# City of Franklin

### Historic Zoning Commission

Monday, November 10, 2025

## Current Green Awning

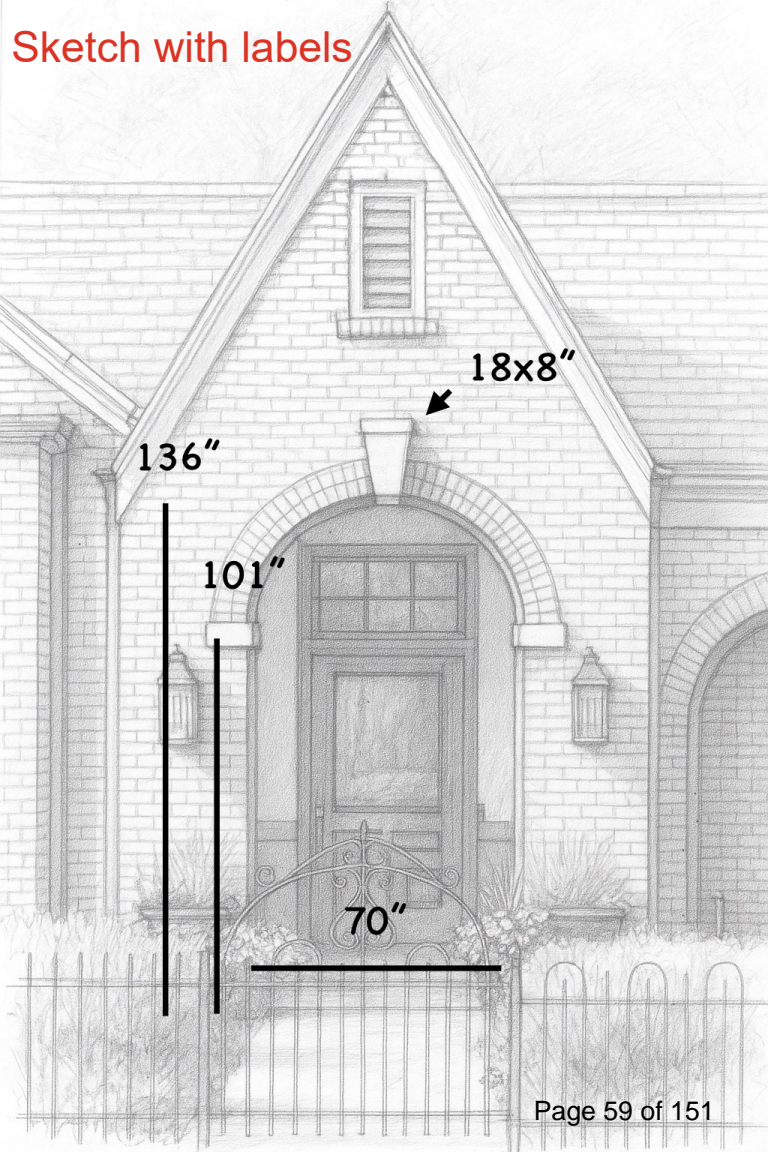
The proposed alteration to the squared opening is not appropriate as the opening has been historically square, prior to and after the bricking of the building based on historic photos. The brick arch and capstone would add a new architectural feature to the front façade and is not appropriate.

1. The mortar must match the original in composition and appearance.
2. The application must meet all the requirements of the City of Franklin prior to issuance of a building permit.
3. Any additional changes to the approved plans must be returned to the Preservation Planner or the Historic Zoning Commission for review and approval.

## 713 GLASS LANE - SUPPORTING PHOTOS

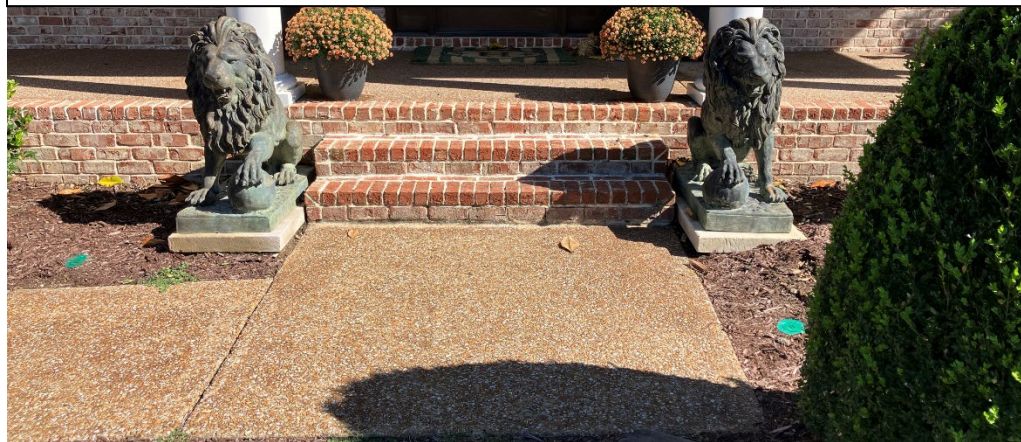
The six existing columns on the front of the building are 8" in diameter. It is proposed to replace the columns with 10" square columns. The Guidelines recommend the following:

A mix of rounded and square columns are seen in the Boyd Mill Avenue Historic District and the proposed change aligns with the Guidelines recommendation.

It is proposed to widen the porch steps to be centered with the columns, remove the existing concrete aggregate that is existing on the porch floor, step treads, and walkway with Indiana Limestone. The Indiana Limestone is a unique material that is not commonly seen in the district, as it is typical to see more aggregate concrete, concrete with a brushed finish, brick, and a lighter gray stone for porch floors, front steps, and walkways. The Guidelines recommend:

1. The widening of the front porch steps shall match in brick and mortar color to what is existing.
2. The application must meet all the requirements of the City of Franklin prior to issuance of a building permit.
3. Any additional changes to the approved plans must be returned to the Preservation Planner or the Historic Zoning Commission for review and approval.

DETACHED GARAGE ELEVATIONS  
KATY BELL INTERIORS

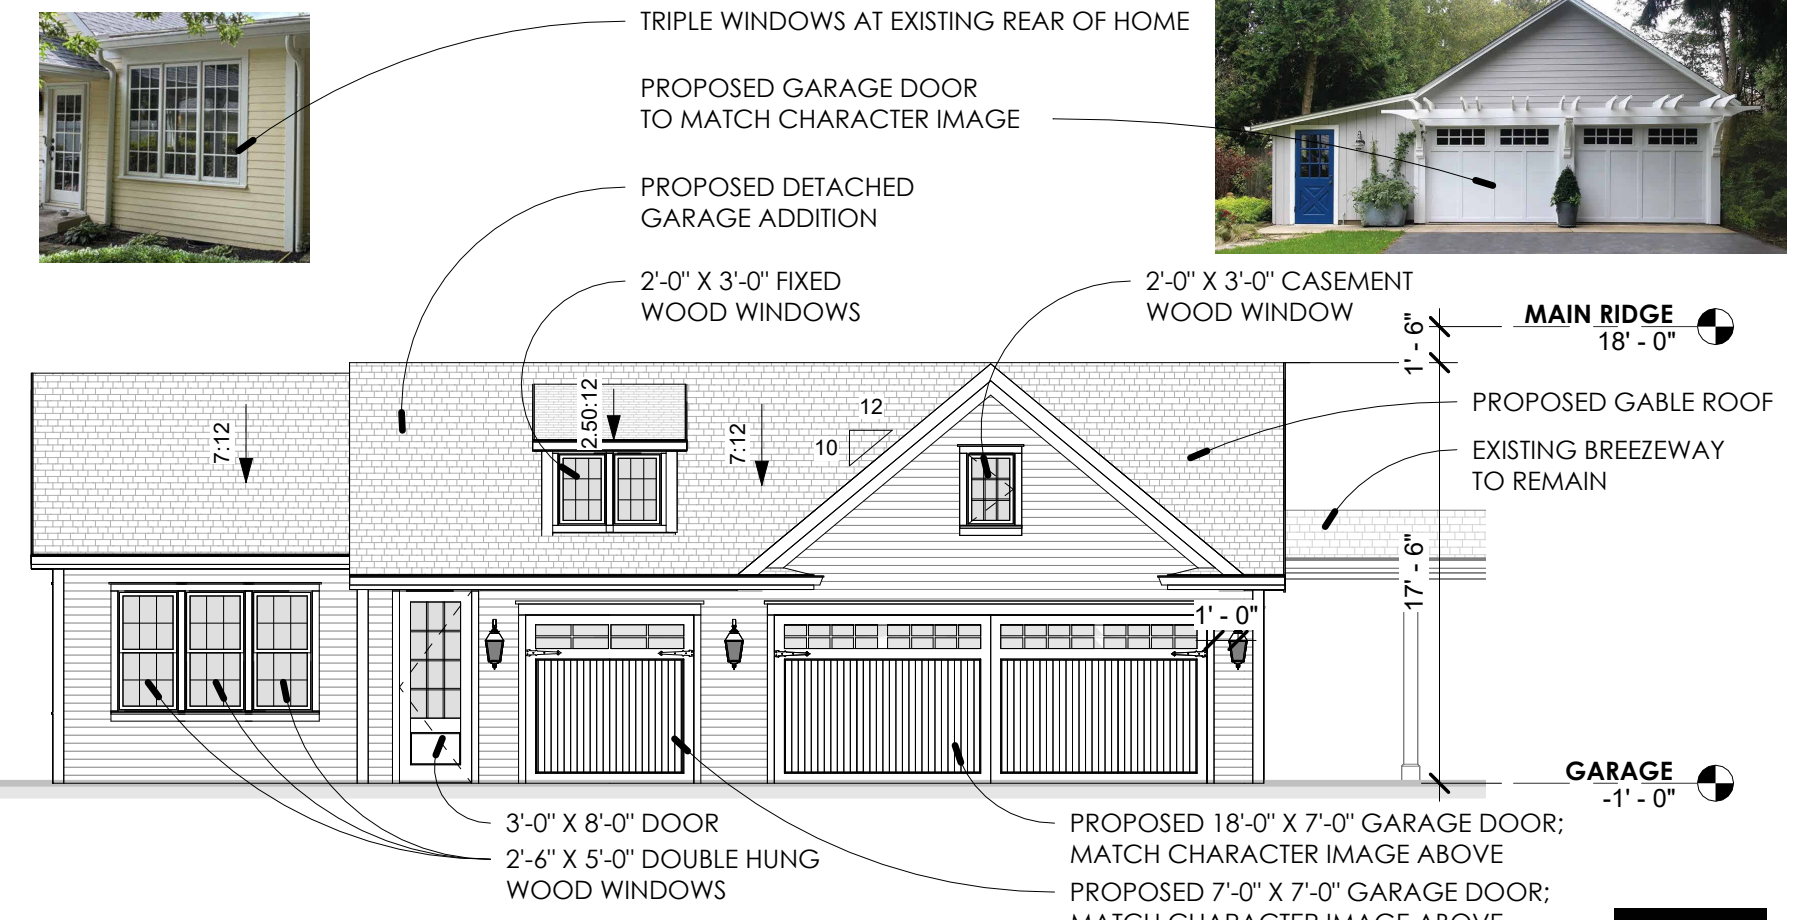
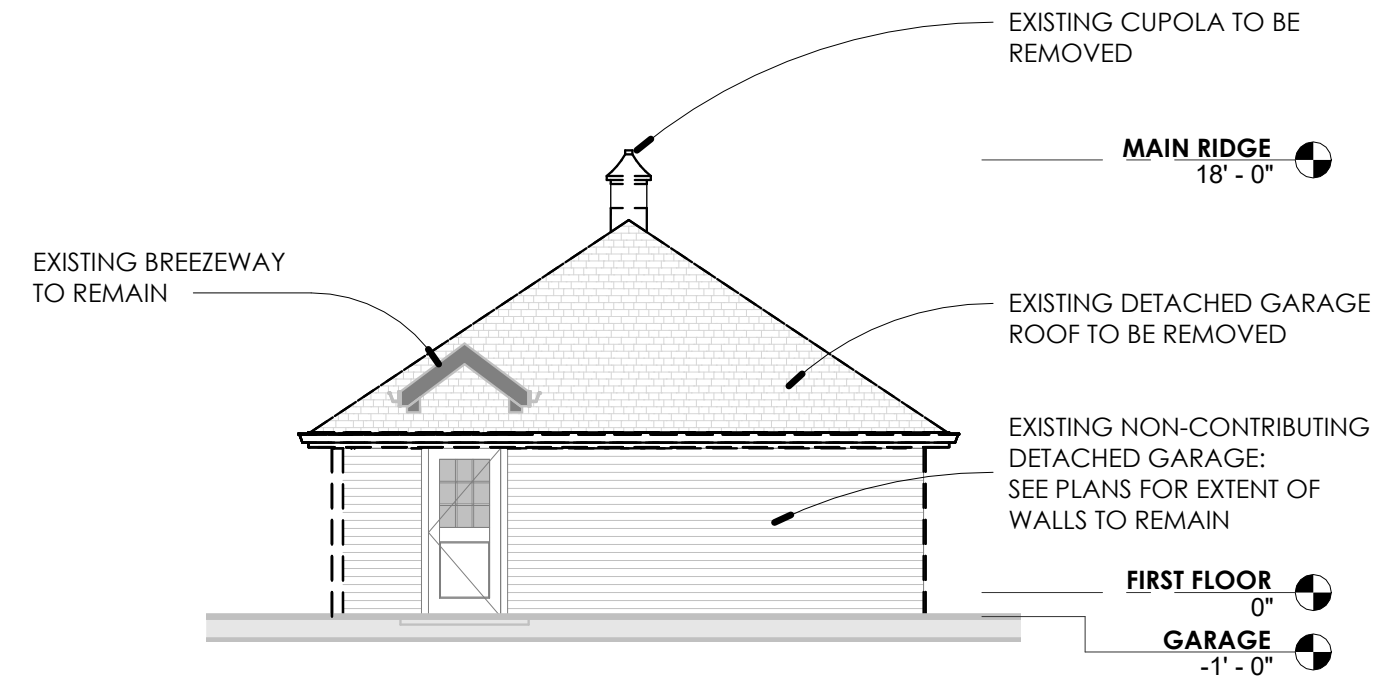
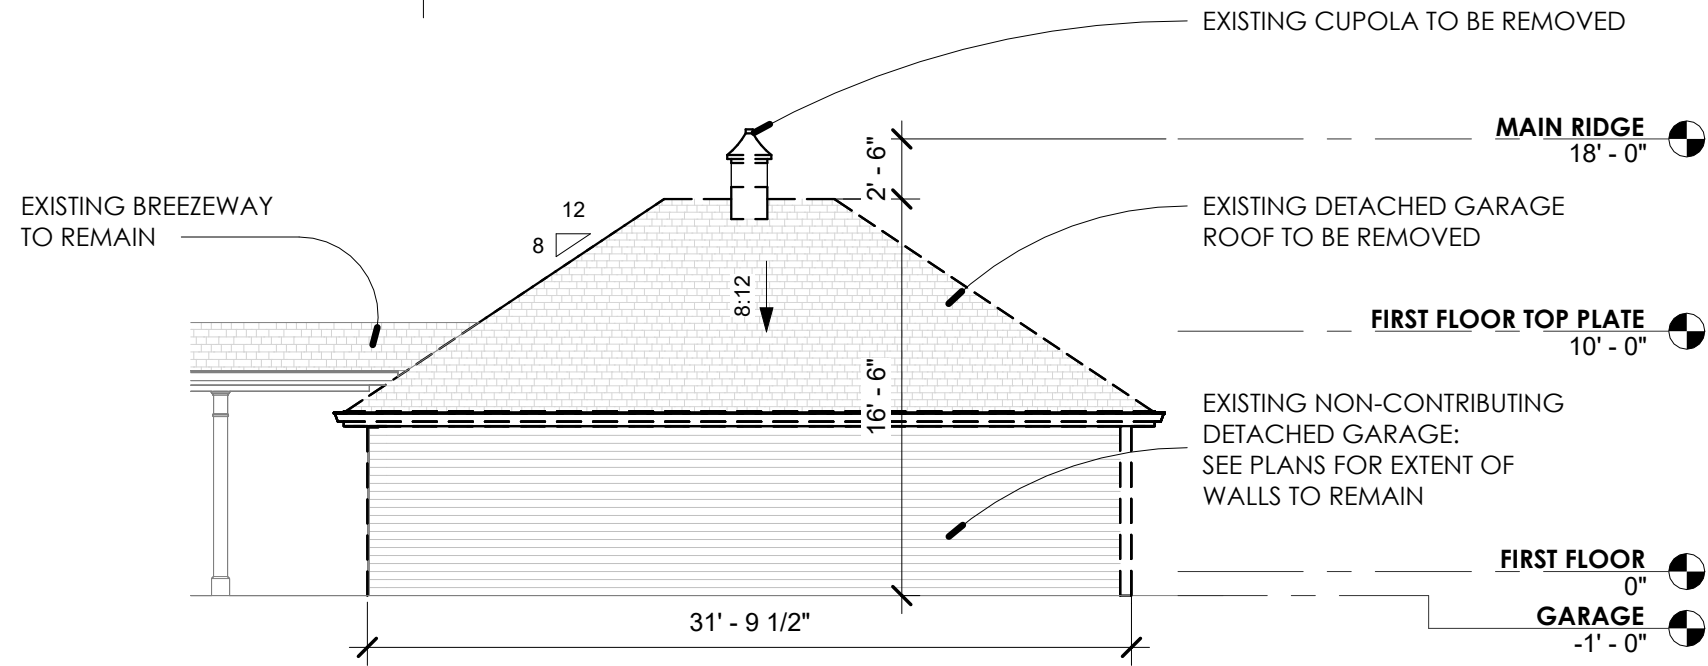
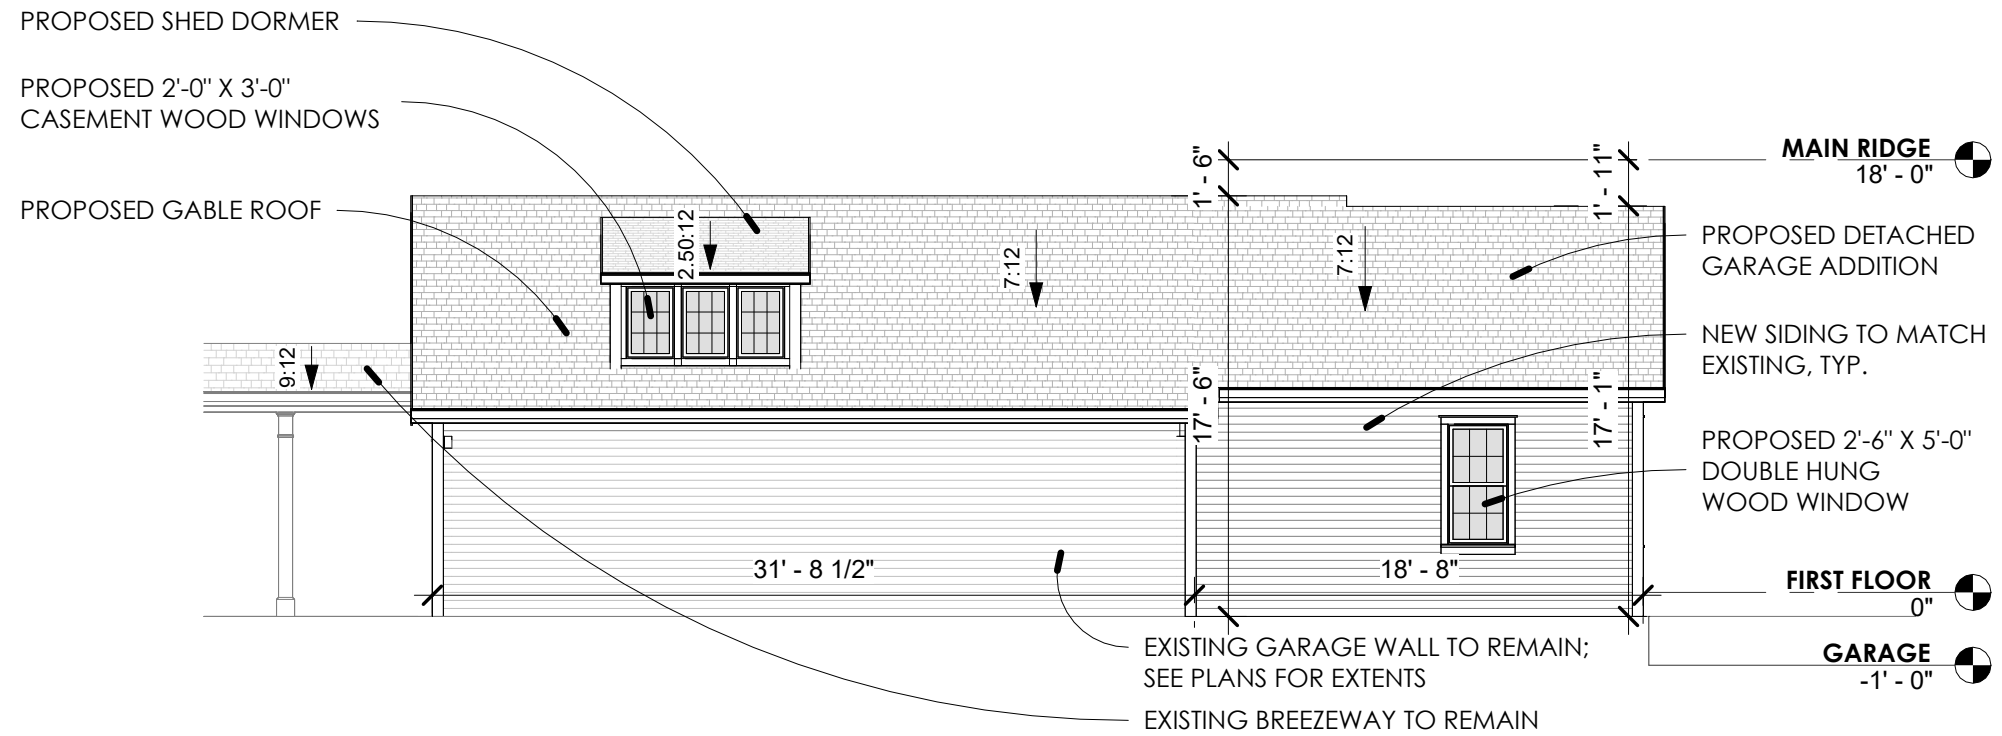
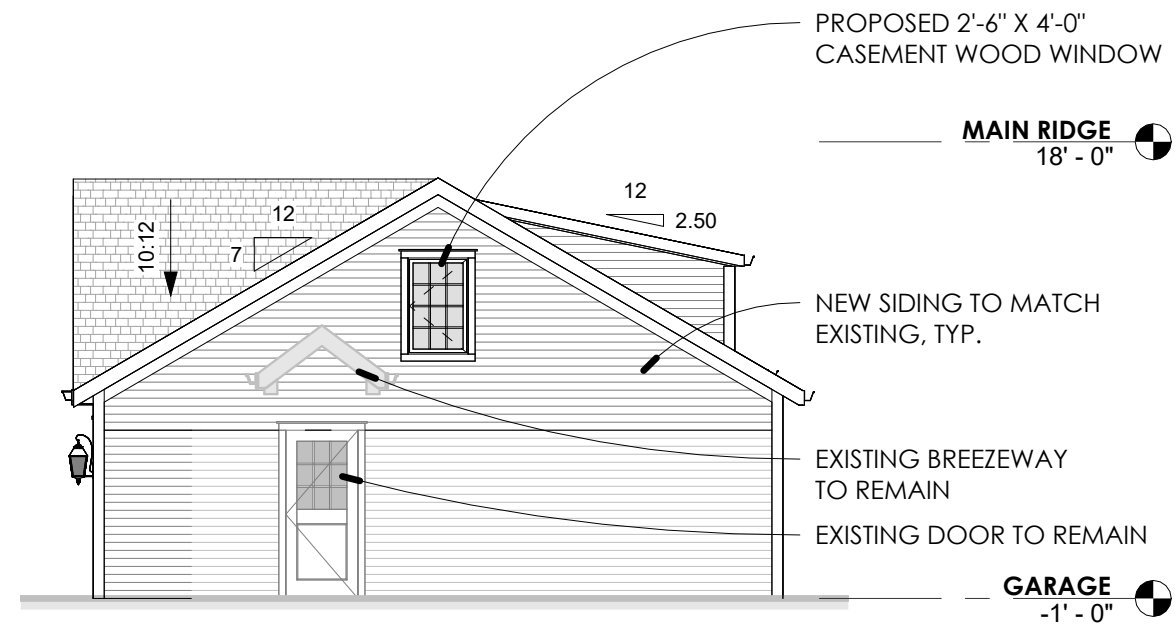
Applicant Presentation: Jacob Layne, 906 Studio Architects. Mr. Layne stated that the height of the accessory structure is 7" below the main ridge line as the ridge line was measured from the first floor to the ridge. The accessory structure is 7" below the height of the main house as shown in the elevation plan.

Chair LeMarinel stated that he was pleasantly surprised about the changes made to the plan from where the application began with the complicated roofline. Chair LeMarinel noted that the extra lines in drawings will show up softer in real life and, regarding the height issue, the original roof pitch of 8/12 and 30" below, and now it's a shallower roof pitch of 7/12 but is taller. Chair LeMarinel stated that it makes him think the bearing height has been raised.

Chair LeMarinel stated that the Commission has seen versions of the plan that had a gable of sorts on the façade over the garage doors making the building feel massive. If there could be more of a dormer gable instead of two shed dormers to achieve space internally and cut down on the massing, that could be an option. Chair LeMarinel noted that he agrees with the motion and stated the proposal has come a long way but is not quite ready for approval.

**Alterations:**  
The alterations proposed to the non-historic accessory structure will alter the roofline from a pyramidal roof to a side gable, add a front-facing gable, shed dormers, a new garage bay, new garage doors, windows, and light fixtures. The height of the structure will increase to 17'6". The proposed dormers will have a 2.5:12 pitch. The materials will match those of the existing structure

The proposed alterations to the existing structure are appropriate. Specifications for the windows and doors shall be submitted to preservation planning staff to ensure the profile is compatible with the profile of windows on historic buildings. The use of fixed windows, while less common on historic buildings, is found on the principal building on the property and appears to be compatible with the existing windows.

1. The garage doors must match the inspiration character image for both the larger door and smaller garage door and a specification sheet must be submitted to the Preservation Planner prior to building permit issuance.
2. The window specifications must be submitted to the Preservation Planner to ensure a historic profile is proposed.
3. The lighting specifications must be submitted to the Preservation Planner or the Historic Zoning Commission prior to installation for review and approval.
4. The application must meet all the requirements of the City of Franklin prior to issuance of a building permit.
5. Any additional changes to the approved plans must be returned to the Preservation Planner or the Historic Zoning Commission for review and approval.
